**TRANSMITTAL OF RESPONSES TO OHIO ENVIRONMENTAL PROTECTION
AGENCY COMMENTS ON THE DRAFT CERTIFICATION DESIGN LETTER FOR
AREA 6 SITEWIDE RAIL LINE SYSTEM**

**RESPONSES TO THE
OHIO ENVIRONMENTAL PROTECTION AGENCY
COMMENTS ON THE
DRAFT CERTIFICATION DESIGN LETTER
FOR AREA 6 SITEWIDE RAIL LINE SYSTEM**

**RESPONSES TO OHIO ENVIRONMENTAL PROTECTION AGENCY COMMENTS ON THE
DRAFT CERTIFICATION DESIGN LETTER FOR AREA 6 SITEWIDE RAIL LINE SYSTEM
(20600-PL-0008, Revision A)**

L INVESTIGATION OF RAIL YARD AREA

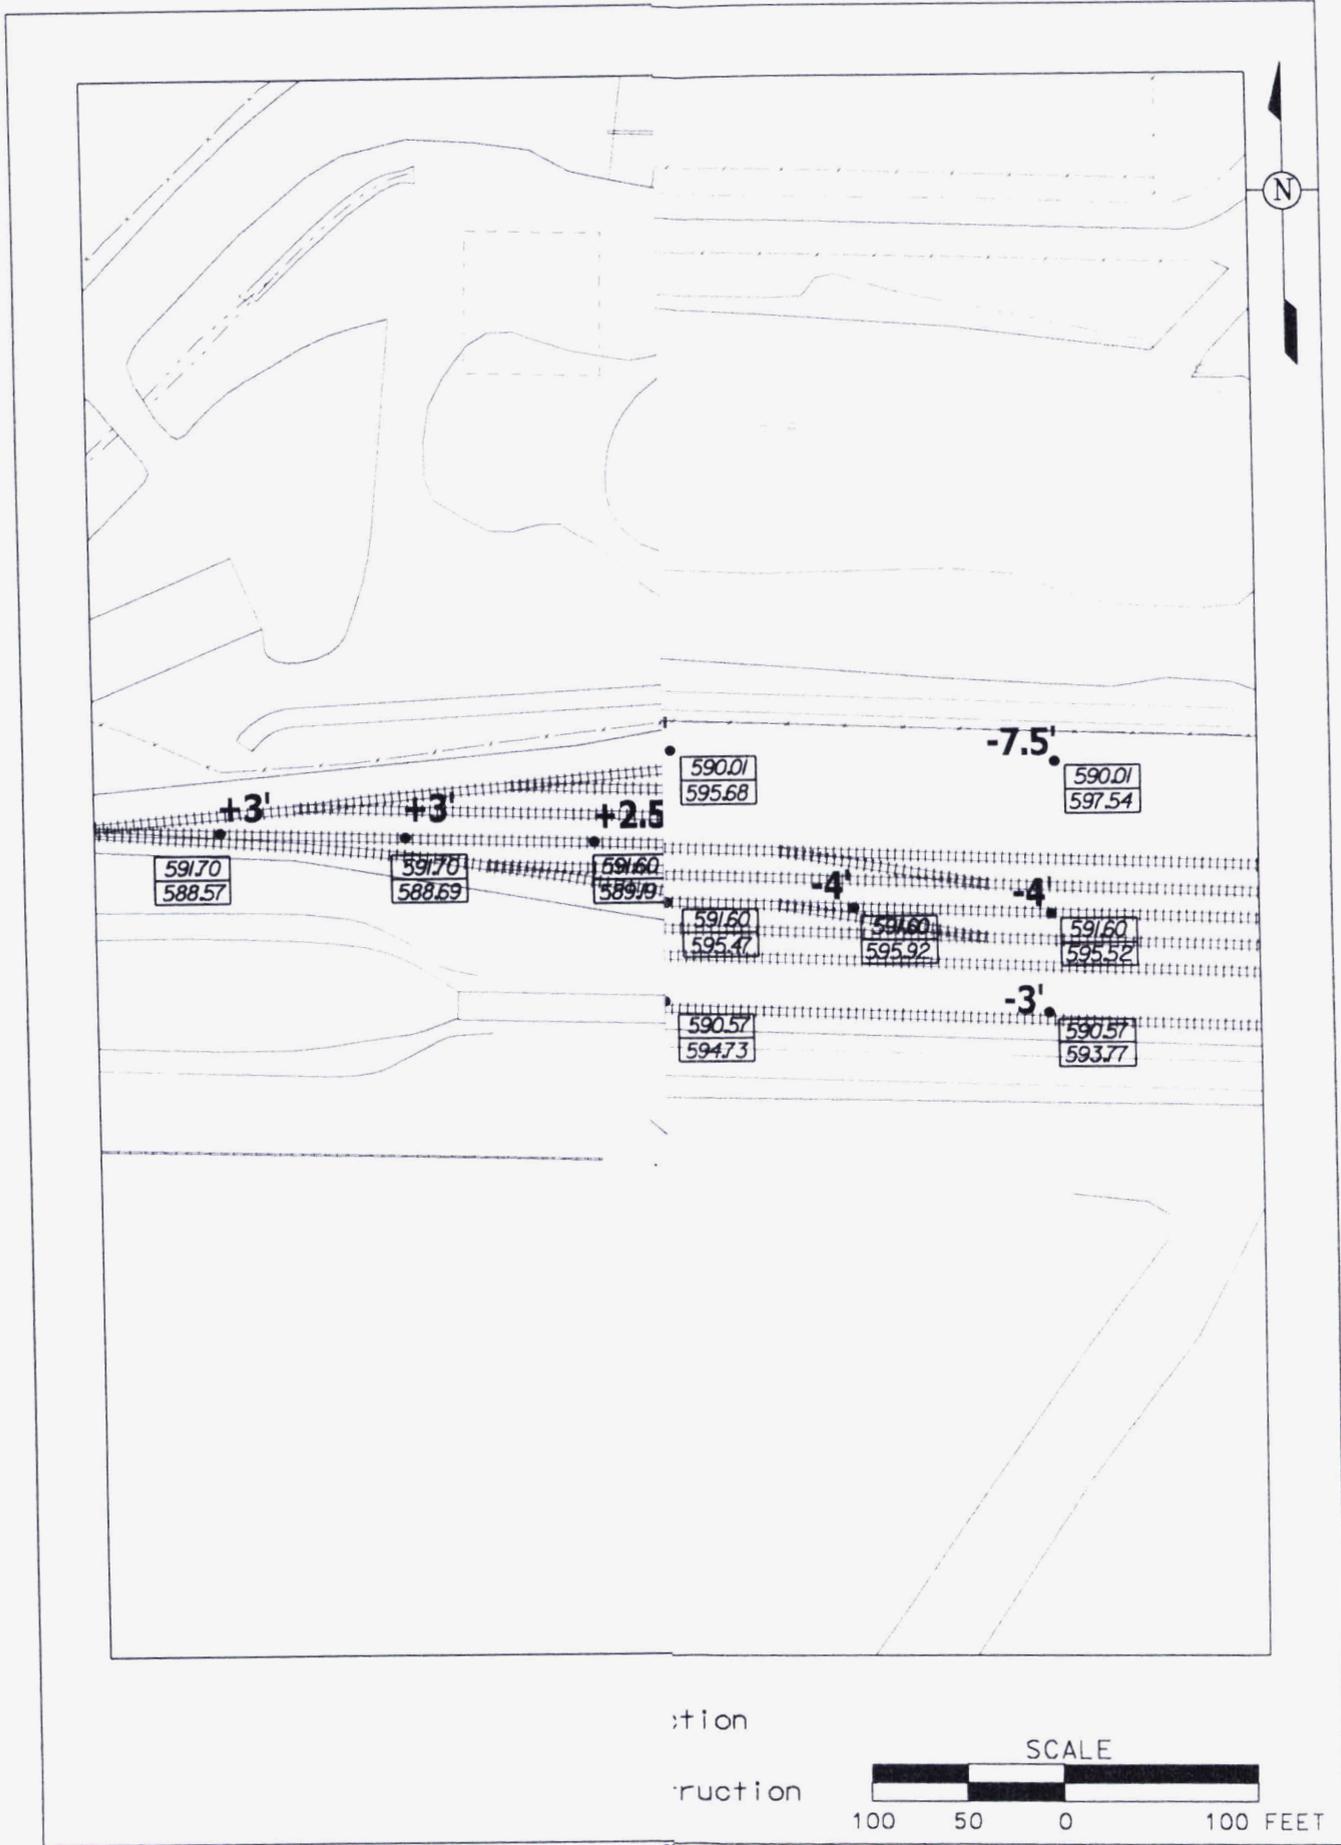
3. Commenting Organization: Ohio EPA
Section #: 2.1 Pg #: 2-1 Commenter: OFFO
Original Comment #: 3 Lines #: 22-27 Code: C
Comment: This paragraph is unclear.

- A) It states that during rail yard construction a surface scrape was conducted "over much of the area" to remove contamination. The text should include a description of the exact area that was scraped or a figure showing where the scrape was done.
- B) The text continues describing how the east half of the railyard wasn't investigated due to "rail operations," but was "cut up." Please provide clarification.
- C) The text further states that the "original assumption was confirmed." This statement does not follow previous sentences. Explain what assumption and why?

Response: A) Agree. Section 2.1 was ambiguous in the discussion of how and where fill material was handled during the construction of the rail yard. To provide additional clarification, a figure will be added to the CDL (Figure 2-1) that shows the results of the topographical study that was performed as described in the predesign sampling Project Specific Plan (PSP) and referenced in the Integrated Remedial Design Package for this area.

The text relative to "cut up" was referring to the fact that during the construction of the rail yard, the eastern half of the area was cut (excavated) - up to 4 feet. In other words, the eastern half of the area was excavated to a depth ranging from 0 to 4-feet. Please refer to the added figure (Figure 2-1) that is mentioned in the Response to Item A above.

Action: A, B, and C) Rewrite Lines 22-27 as follows:

"As discussed in the Area 6, Subarea 1 Predesign PSP (DOE 2005d), a field survey investigation of the historical topography of the railyard versus the current soil elevation was completed. Figure 2-1 demonstrates the elevation changes from this area prior to construction of the railyard to the current soil elevation of the railyard. Based on the field survey investigation, it is evident that the eastern half of the railyard was excavated to a depth ranging up to 4 feet. Additionally, the elevation of the western half was increased ranging from 0.5-feet to 3-feet demonstrating a cut and fill operation, where soil that was cut from the east was used for fill on the west."
